# Access Compliance Report

## Public Rights-of-Way

### (Curb Ramps)

Intersection ID: 1001741	Main Street: FLAT_RIVER_DR	Cross Street: OVERLAND_PARK_LN	Location: E
ADA ID: 7B02A32E7B8D	Ramp Type: Perp	Initial Pass/Fail: Fail	Overall Compliance: No
		Severity Score: 25

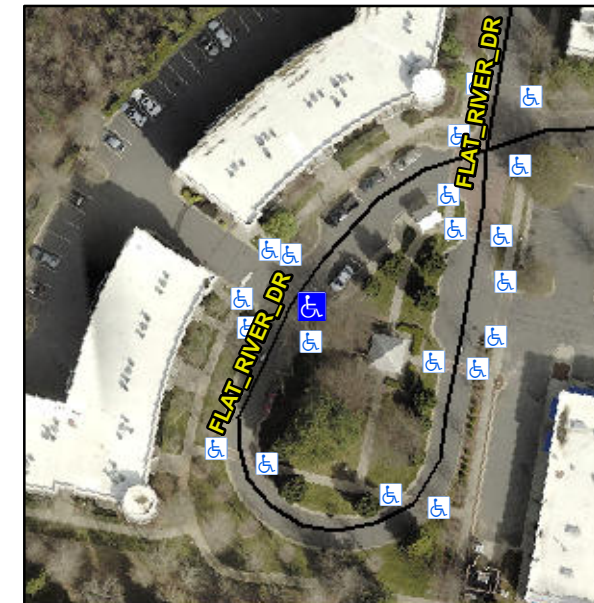
Compliance	Description	Data	Compliance	Description	Data
N/A	Ramp Length (in)	65.5	No	Ramp Slope (%)	16.7
Yes	Ramp Width (in)	53.5	Yes	Ramp XSlope (%)	1.3
N/A	Flare Type LT	N/A	N/A	Flare Type RT	N/A
N/A	Flare Slope LT (%)	N/A	N/A	Flare Slope RT (%)	N/A
N/A	Flare Traversable LT?	N/A	N/A	Flare Traversable RT?	N/A
N/A	Landing Length (in)	N/A	N/A	DWS Provided?	N/A
N/A	Landing Width (in)	N/A	N/A	DWS Contrast?	N/A
N/A	Landing Slope (%)	N/A	N/A	DWS Length (in)	N/A
N/A	Landing X Slope (%)	N/A	N/A	DWS Full Width?	N/A
N/A	Landing Curb? (Y/N)	N/A	N/A	DWS Offset (in)	N/A
N/A	Shared Landing?	N/A			
N/A	Gutter Ponding?	N/A	N/A	Gutter Slope (%)	N/A
N/A	Gutter Lip Ht (in)	N/A	N/A	Gutter X Slope (%)	N/A
N/A	Painted X Walk1?	No	N/A	Painted X Walk2?	N/A
	X Walk 1 Direction	To NW		X Walk 2 Direction	N/A
N/A	X Walk 1 Width (in)	N/A	N/A	X Walk 2 Width (in)	N/A
	X Walk 1 Slope (%)	2.3		X Walk 2 Slope (%)	N/A
	X Walk 1 X Slope (%)	0.2		X Walk 2 X Slope (%)	N/A

**Remove & Replace Entire Ramp.**

**R304.2.2**
